Access Compliance Report

Public Rights-of-Way

Intersection ID: 24562	Main Street: CAVAN_CT	Cross Street: SWINFORD_PL	Location: NE
ADA ID: 81A1594ADDD9	Ramp Type: Perp	Initial Pass/Fail: Fail	Overall Compliance: No
Severity Score: 33.75			
Codes/Mitigation Info/Possible Solution		Field Measurements/Component Compliance

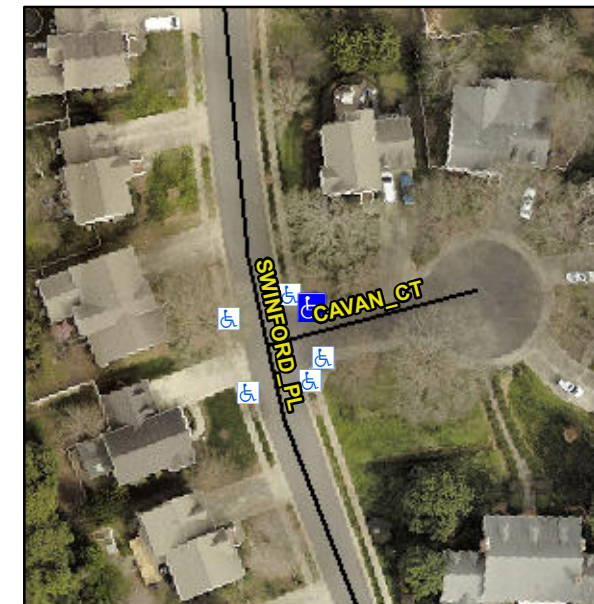
R304.5.1, R304.5.3

Compliance	Description	Data	Compliance	Description	Data
N/A	Ramp Length (in)	48.0	Yes	Ramp Slope (%)	6.2
No	Ramp Width (in)	41.5	No	Ramp XSlope (%)	7.2
N/A	Flare Type LT	N/A	N/A	Flare Type RT	N/A
N/A	Flare Slope LT (%)	N/A	N/A	Flare Slope RT (%)	N/A
N/A	Flare Traversable LT?	N/A	N/A	Flare Traversable RT?	N/A
N/A	Landing Length (in)	N/A	N/A	DWS Provided?	N/A
N/A	Landing Width (in)	N/A	N/A	DWS Contrast?	N/A
N/A	Landing Slope (%)	N/A	N/A	DWS Length (in)	N/A
N/A	Landing X Slope (%)	N/A	N/A	DWS Full Width?	N/A
N/A	Landing Curb? (Y/N)	N/A	N/A	DWS Offset (in)	N/A
N/A	Shared Landing?	N/A			
N/A	Gutter Ponding?	N/A	N/A	Gutter Slope (%)	N/A
N/A	Gutter Lip Ht (in)	N/A	N/A	Gutter X Slope (%)	N/A
N/A	Painted X Walk1?	No	N/A	Painted X Walk2?	N/A
	X Walk 1 Direction	To S		X Walk 2 Direction	N/A
N/A	X Walk 1 Width (in)	N/A	N/A	X Walk 2 Width (in)	N/A
	X Walk 1 Slope (%)	2.2		X Walk 2 Slope (%)	N/A
	X Walk 1 X Slope (%)	3.5		X Walk 2 X Slope (%)	N/A

Remove & Replace Entire Ramp.
